VERIFICATION REPORT AND CERTIFICATION STATEMENT

**Longyuan (Beijing) Carbon Asset
Management Technology Co., Ltd.**

**Gansu Yumen Sanshilijingzi Wind
Power Project**

Date of Issue:		Project Number:	
26-06-2009		CCP.VOL0606C	
Project Title:			
Gansu Yumen Sanshilijingzi Wind Power Project			
Organisation:		Client:	
SGS United Kingdom Limited		Longyuan (Beijing) Carbon Asset Management Technology Co., Ltd	
Publication of Monitoring Report:			
Monitoring Period:		01/06/2008 - 07/01/2009	
First Monitoring Version and Date:		Version 1.0, 15/04/2009	
Final Monitoring Version and Date:		Version 2.0, 15/05/2009	
Summary:			
<p>SGS United Kingdom Ltd has performed the first verification of the VCS2007.1 project Gansu Yumen Sanshilijingzi Wind Power Project (UNFCCC Ref. No. 2193). The verification includes confirming the implementation of the monitoring plan in the registered CDM PDD and the application of the monitoring methodology as per ACM0002 version 06. A site visit was conducted to verify the data submitted in the monitoring report.</p> <p>Gansu Yumen Sanshilijingzi Wind Power Project is a grid connected renewable energy project located in Yumen Town, Yumen City, Gansu Province, Ch

Figure 3 Simplified electrical grid connection diagram

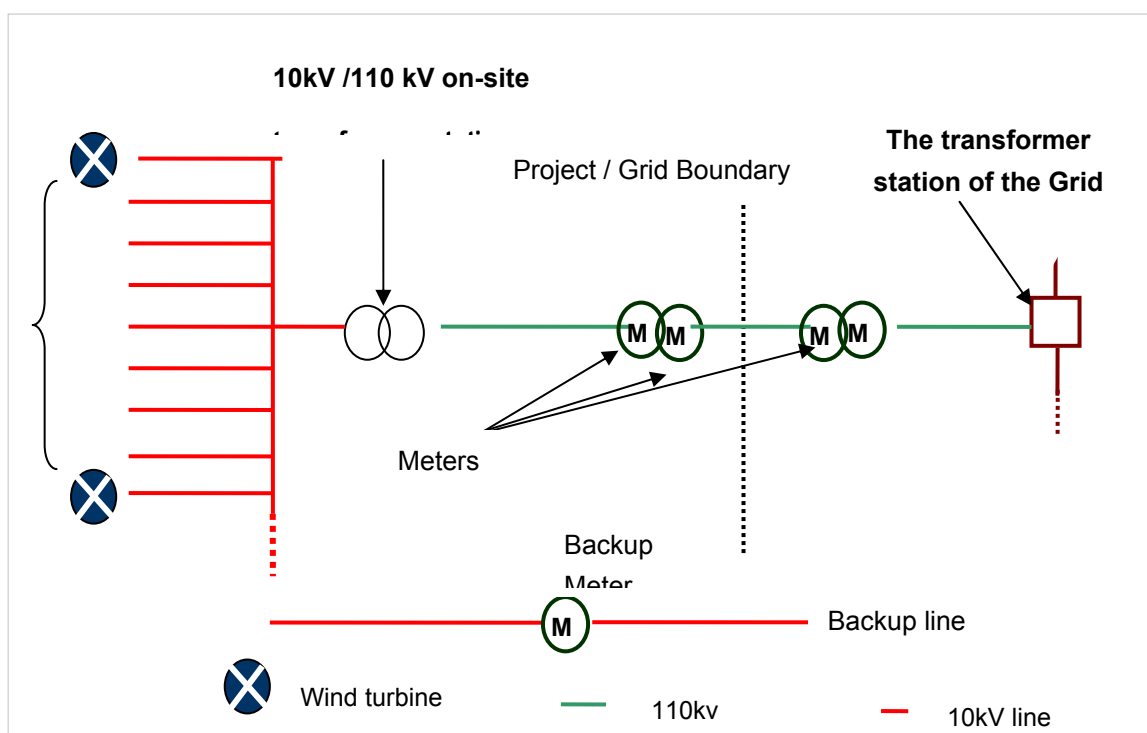
Through onsite visit, it was found that there was one backup line used to import electricity from the grid instead of no backup line as stated in the PDD and there were two meters installed at the transformer station instead of one key meter as stated in the PDD. **CAR #2 was raised** requesting the PP to revise the monitoring plan to make it in compliance with the actual situation. The revised monitoring plan (/5/) has been provided and validated to be in compliance with the actual situation.

Date:	08/05/2009	Raised by:	Michael Wu Shimin and Simon Zhao Xinguang		
Type:	CAR	Number:	CAR #2	Reference:	1.1
Lead Assessor Comment:			Date: 08/05/2009		
During onsite visit, it was found that there was one backup line used to import electricity from the grid instead of no backup line as stated in the PDD and there were two key meters installed at the transformer station instead of one key meter as stated in the PDD. Please revise the monitoring plan to make it in compliance with the actual situation.					
Project Participant Response:			Date: 15/05/2009		
The monitoring plan has been revised accordingly and delivered to the DOE.					
Documentation Provided as Evidence by Project Participant:					
Revised Monitoring Plan, 15/05/2009 Electricity Sales Receipts Monthly Metering Record Data					
Information Verified by Lead Assessor:

In compliance with Annex 34 to EB 26 meeting report and Chapter VI section E subsection 3 paragraphs 207 and 208 of the VVM (/27/), it has been validated that this revision of monitoring plan improves the accuracy and completeness of information needed, consistency in the registered PDD and the monitoring plan. The revision of monitoring plan is in accordance with the approved monitoring methodology (ACM0002 version 06) applicable to the project activity and the findings raised during the first verification of the project against VCS 2007.1 have been taken into account. **CAR #2 was closed.**

Revised Monitoring Plan	
Reasoning for not Acceptance or Acceptance and Close Out:	
<p>In the revised monitoring plan of the project, it is stated that total electricity delivered to the grid by the project ($E_{G_{ex}}$), electricity imported from the grid by the project through the main line ($E_{im_main\ line}$) and electricity imported from the grid by the project through the backup line ($E_{im_backup\ line}$) need to be monitored. $E_{G_{ex}}$ and $E_{im_main\ line}$ are monitored by two key meters installed in the transformer station and two cross check meters in the project site. $E_{im_backup\ line}$ is monitored by one meter in the backup line.</p> <p>The revised monitoring plan provides a solution to calculate the net electricity delivered to the grid by the project (E_{Gy}) which is used for the calculation of emission reduction, which is the total electricity delivered to the grid by the project from which the electricity imported from the grid by the project through the main line and backup line is deducted. Parameters that need to be monitored have been incorporated in the revised PDD. QA/QC procedures, calibration of meters and data management system have been included in the revised monitoring plan. The revised monitoring plan is validated to be in compliance with the actual situation and improve the accuracy and completeness of the information needed, consistency in the registered PDD and monitoring plan.</p> <p>In compliance with Annex 34 to EB 26 meeting report and Chapter VI section E subsection 3 paragraphs 207 and 208 of the VVM, it has been validated that this revision of monitoring plan improves the accuracy and completeness of information needed, consistency in the registered PDD and the monitoring plan. The revision of monitoring plan is in accordance with the approved monitoring methodology (ACM0002 version 06) applicable to the project activity and the findings raised during the first verification of the project against VCS 2007.1 have been taken into account. CAR #2 was closed.</p>
